# Summary of Written and Oral Submissions

## Zoning By-law Amendment – 1705 Carling Avenue

# Appendix 1: Revised Document 1– Location and Zoning Map

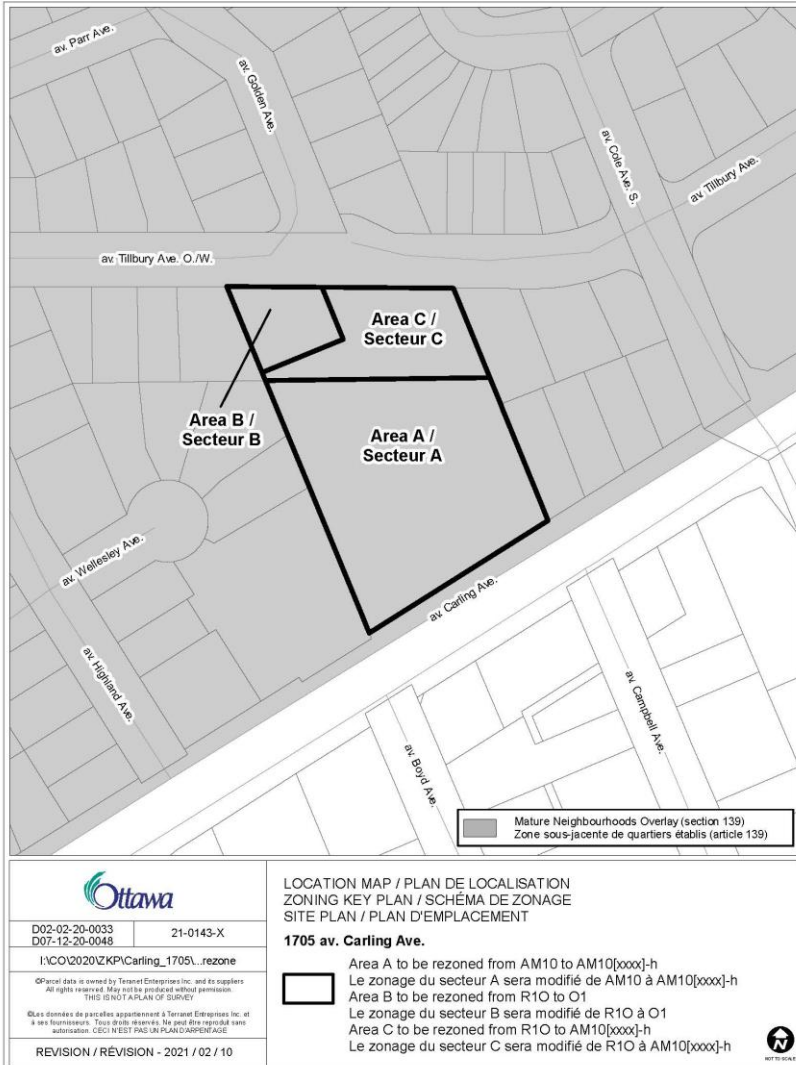
1. **Replace Document 1 of Report ACS2021-PIE-PS-0031 with a revised location and zoning map referencing the existing R10 zoning**

designation, listed as Appendix 1<sup>1</sup> to this motion;

# Appendix 2 – New Document 8 – Zoning Schedule

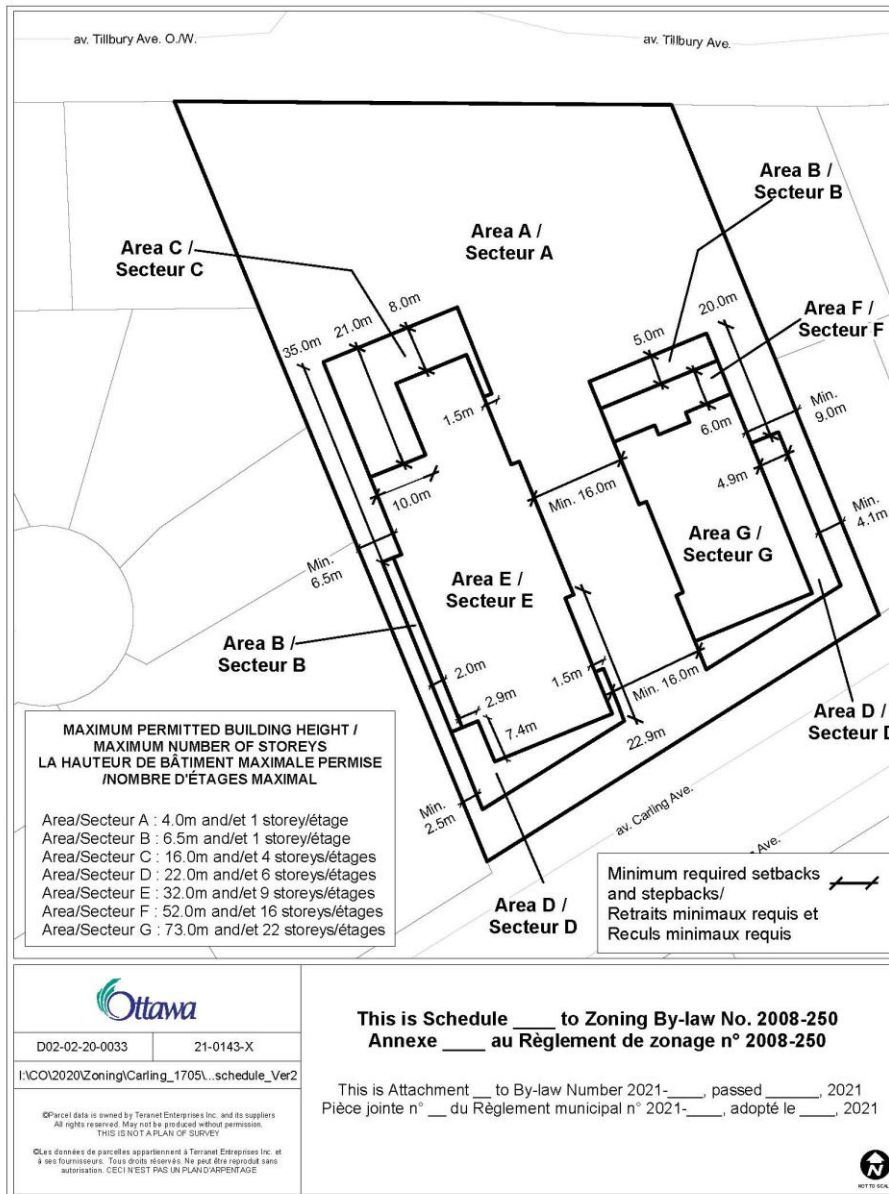
- they request a “shrink wrapped” Zoning Schedule that includes the specific heights associated with each building as shown on the Site Plan, designates the Park as Open Space and lists the amenity space at the rear of the property as permitting zero meters of building height and/or is consistent with the R1O zone, which will provide certainty and clarity to the process, and ensure that the permission for the 9-storey Seniors’ Residence does not become a much taller building in a future development scenario

2. Add a new 'Document 8 – Zoning Schedule' to Report ACS2021-PIE-PS-0031, listed as Appendix 2<sup>2</sup> to this motion;
3. Amend Document 2 to introduce a new the Zoning Schedule, and include wording: 'Amend Part 17, by adding a new Schedule “YYY”, as shown in Document 8';
4. Amend Document 2 to remove 2(c)(ii),(iii),and(iv), as these will instead be clearly referenced in Document 8.
5. Amend Document 2 to include the provision “Permitted projections listed in Section 64 and 65 are not subject to the height limits identified on SYYY” in Column V.
6. Amend Document 2 to replace any reference of “AM10[xxxx]-h” to “AM10[xxxx]SYYY-h”.

Appendix 3: Revised new Document 8 – replacement Zoning Schedule

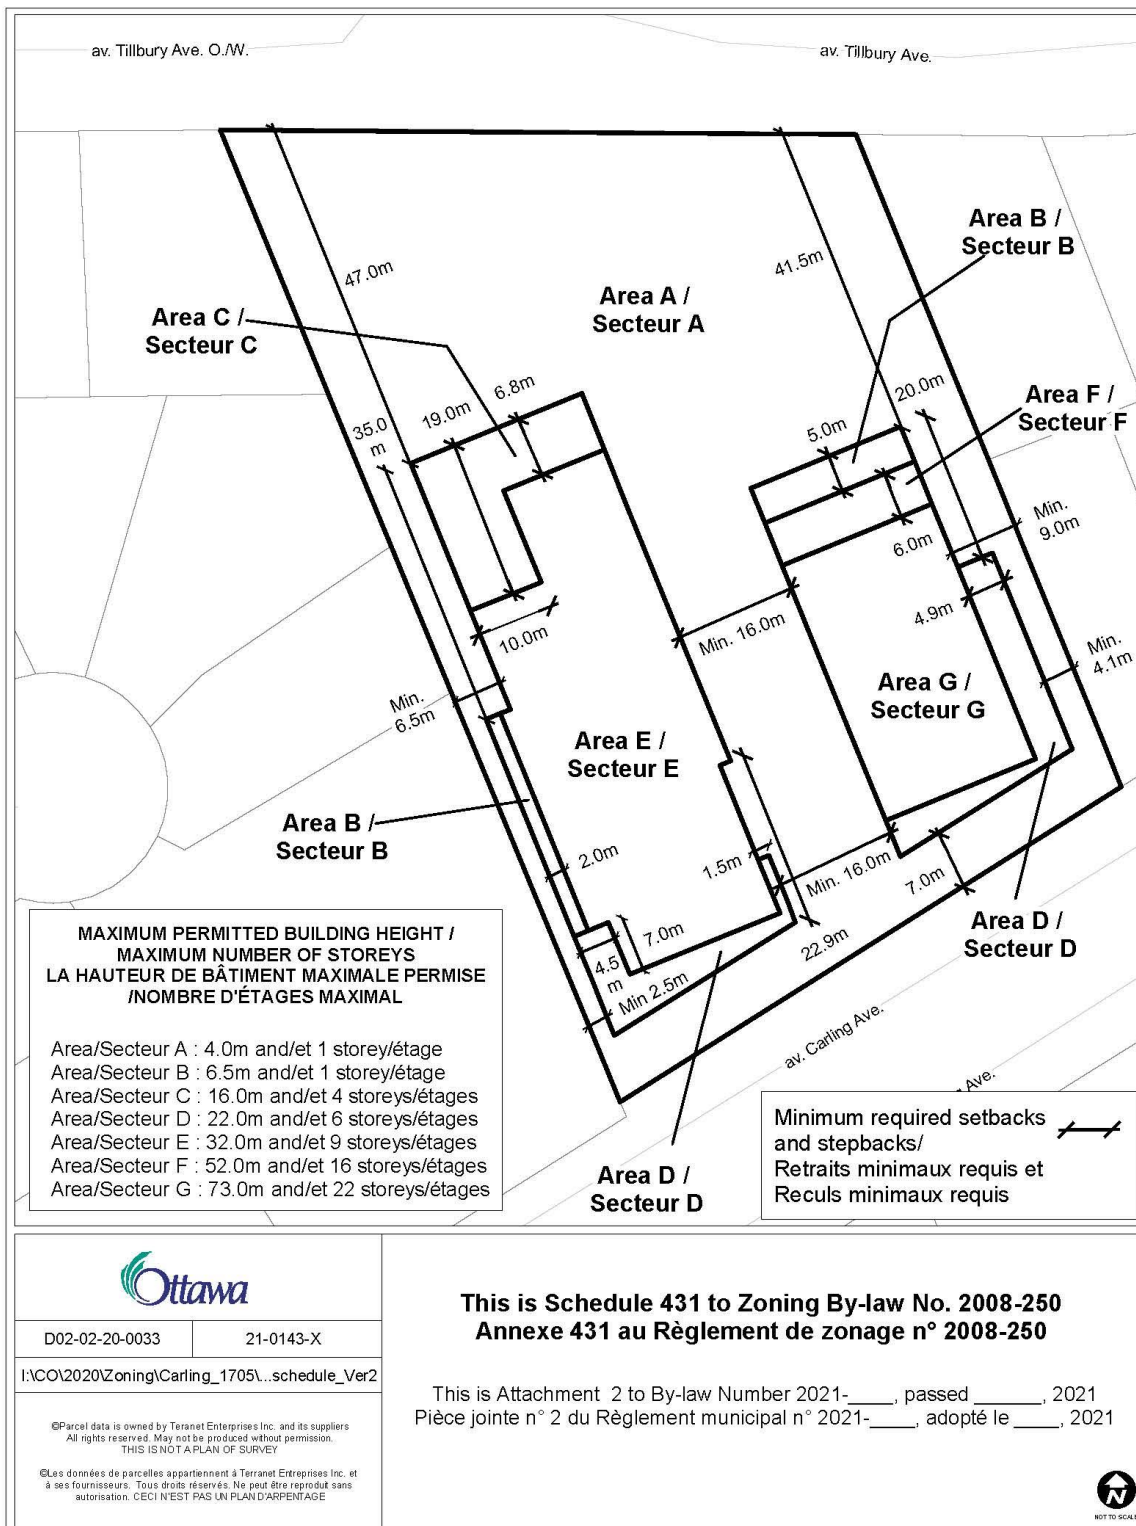
**AND WHEREAS**, subsequent to Planning Committee, the applicant requested minor changes to the Schedule which sets out the permitted heights, setbacks, and step-backs were required to be consistent with the intended design, which are supported by Planning, Infrastructure and Economic Development department;

**THEREFORE BE IT RESOLVED** that Council approve that Document 8 of the said report, as amended by Motion No PLC 2021-37/4, be replaced by the Schedule shown in Attachment 1<sup>3</sup>; and
